Q-292

SVE BULLETIN

QVM Bulletin: Q-292 Date: 15,February,2019

Added Holes in Chassis Cab Frame Rails for After-market Hitch Installation

Reverse Plan View

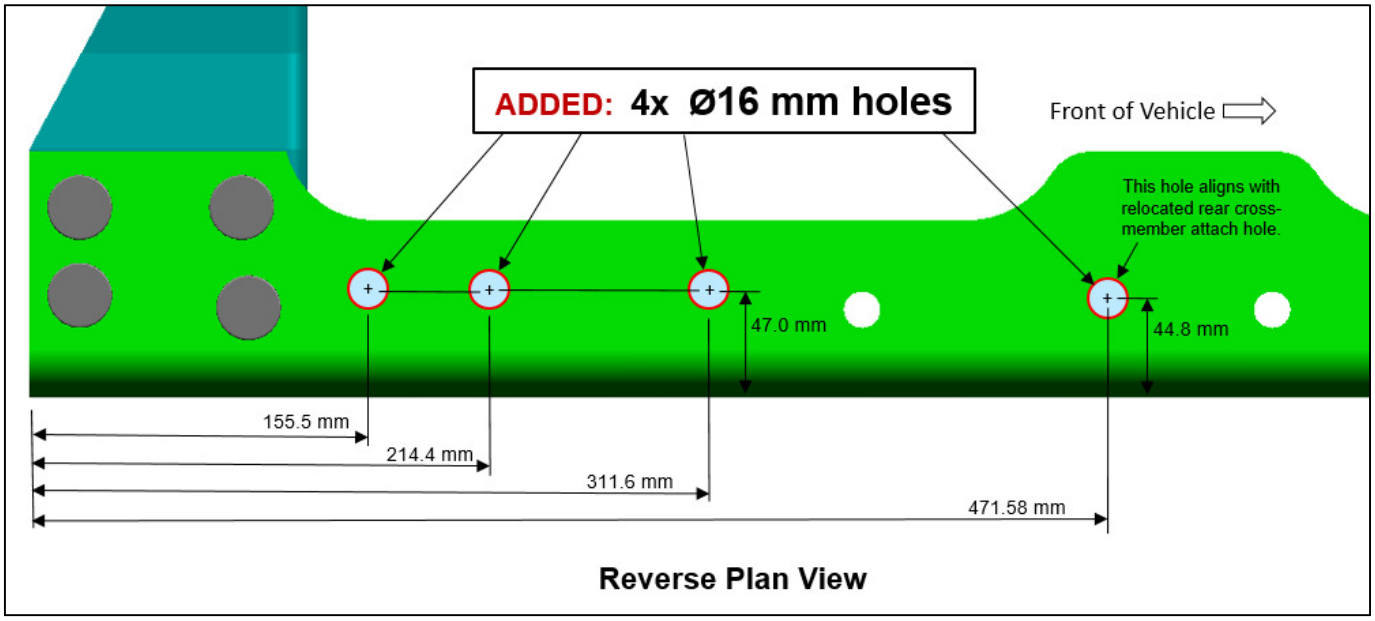
Description: **Four holes per rail, on the bottom flange, have been added to facilitate the installation of aftermarket hitches.**

These holes have been added to help facilitate the installation of aftermarket trailer hitches. Aftermarket hitch load ratings are the responsibility of the aftermarket hitch manufacturer. The maximum trailer tow rating which is published in the RV & Trailer Tow Guide must never be exceeded.

These holes are being provided due to the larger aft-of-axle fuel tank that has inhibited the ability to drill holes in the lower flange of the frame rails for the installation of aftermarket hitches.
